VOLUME 4, NUMBER 9

September 3, 1979

Proposed Amendments to the State Building Code 233

Proposed Amendments to the State Building Code

Fig. 1 U_o Type "A" Buildings
 Type "A" Buildings Shall Include: A₁ Detached One- and Two-Family Dwellings
 A₂ All other Buildings; Three Stories or Less
 Including but not Limited to—Multi-family Dwellings
 Hotel and Motels

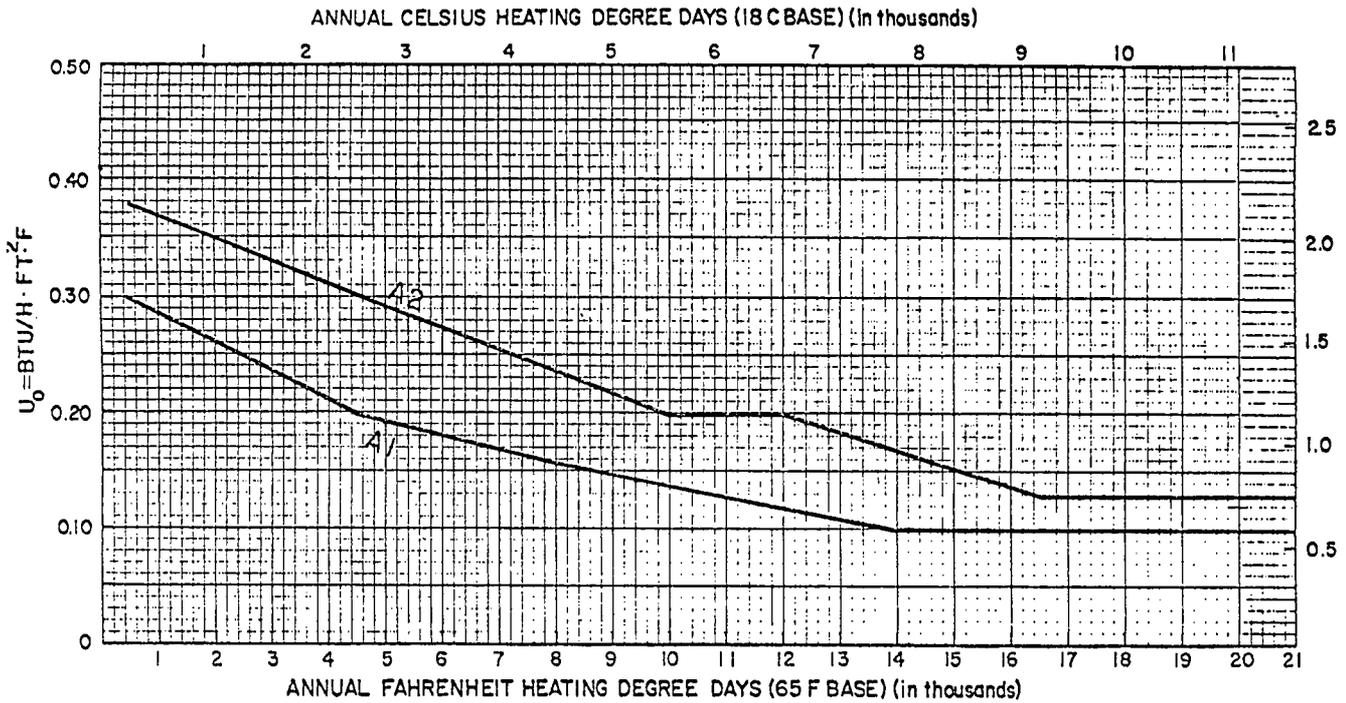
2 MCAR § 1.16005 — ASHRAE 90-75 Figure 1 page 13 is deleted and replaced with the new figure 1 as follows:

FIG 8
 TD_{EO_R} VALUES FOR USE IN EQ. 4

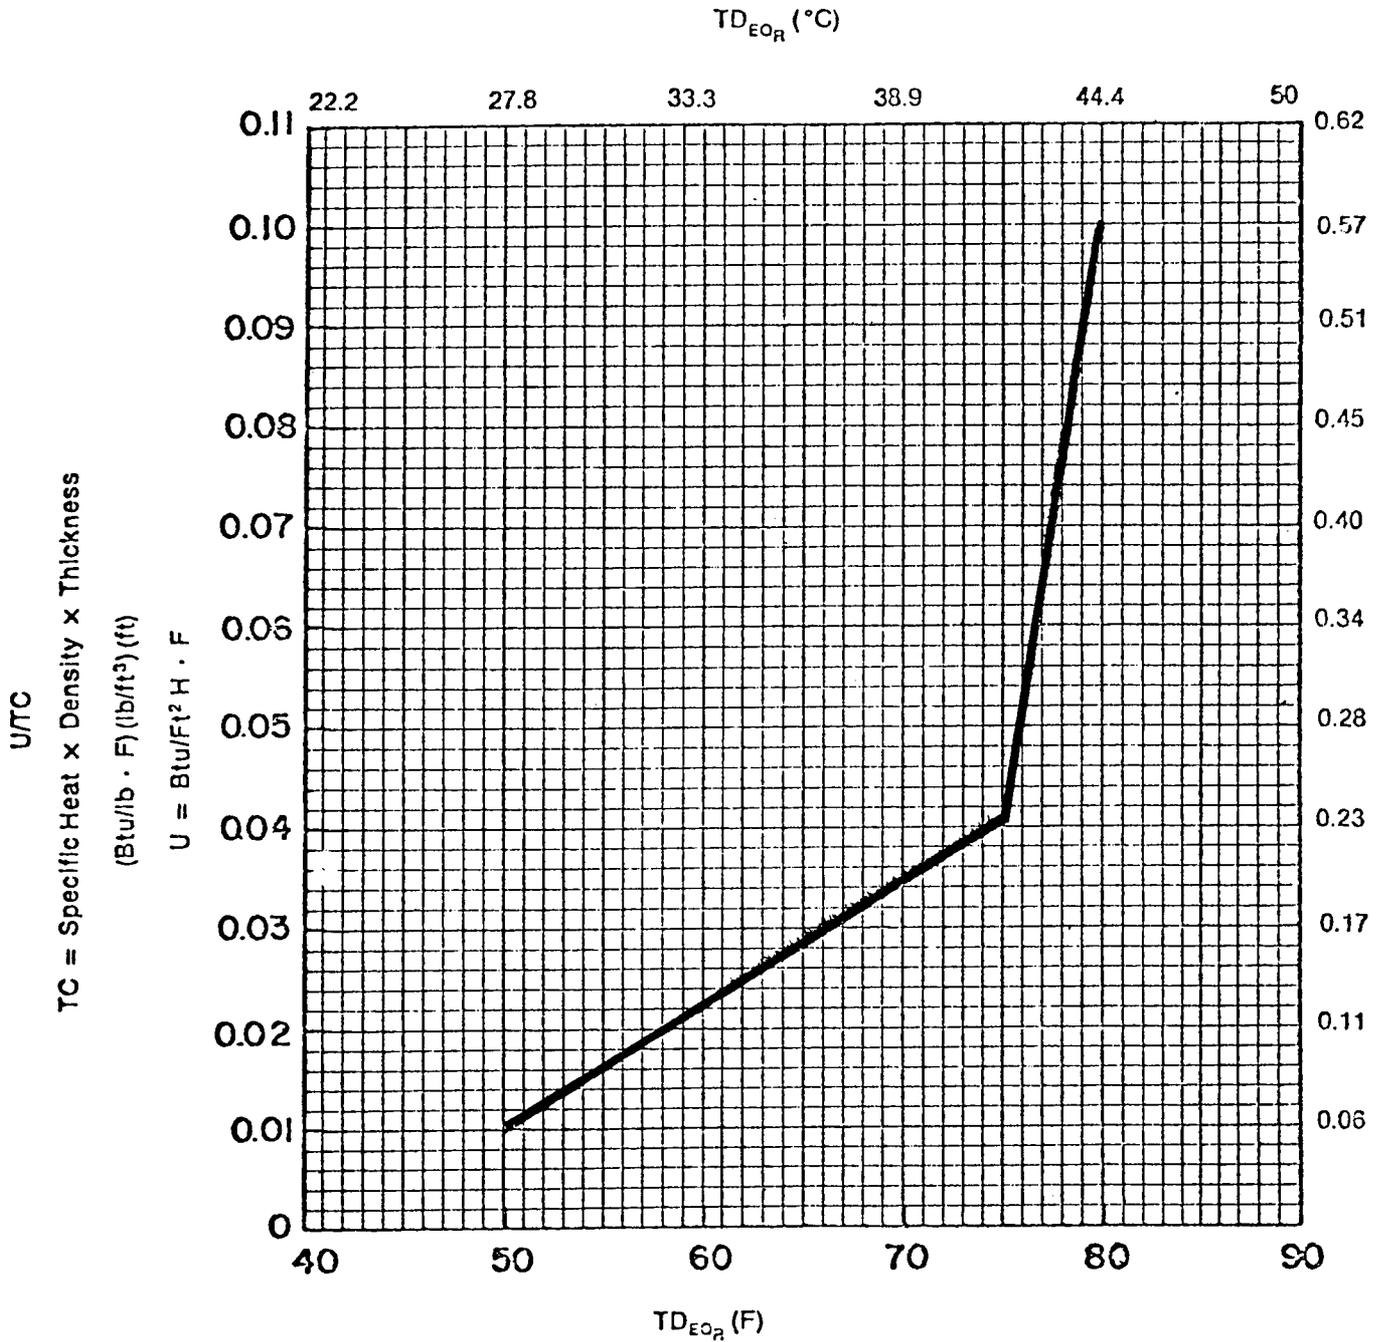
2 MCAR § 1.16005 — ASHREA 90-75 is amended by adding new figure 8 as follows:
